# Technical Bulletin

**Number:** 051  
**Date Issued:** 07/28/05  
**Expiration Date:** 12/30/05

<b>Subject/Key Words:</b>	<b>LuCID2 Rod Adjuster Inspection for Correct Tolerances</b>			
<b>Classification:</b>	<input checked="" type="checkbox"/> Informational	<input checked="" type="checkbox"/> Mandatory	<input type="checkbox"/> Safety Alert	<input type="checkbox"/> PM Impact
	<input checked="" type="checkbox"/> Warranty Impact	<input type="checkbox"/> Purchase Parts	<input checked="" type="checkbox"/> No Charge For Parts expires 12 / 30 / 05. Reference this TB# when ordering NC parts.	
<b>Applicable Akrion Procedures:</b>	OP0398: Functional Test Sheet – GAMA LuCID2 Dryer Module, Item ID: 10, Lid Operation			
<b>Parts/Reference Documents:</b>	Rod Adjuster replacement kit 227793-001

Figure 1

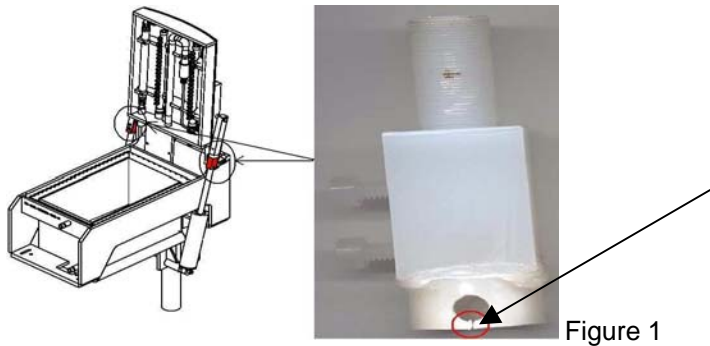
**Issue:** The fixed end of some LuCID2 lid piston rod adjusters may be manufactured to incorrect tolerances. The hole in which the pin mounts may be too close to the end of the adjuster body. This creates a weak area prone to fatigue failures. Note the crack location in Figure 1.

**Symptoms:** Fatigue failures in this area can result in irregular lid operation, potential robot crashes, and piston shaft galling.
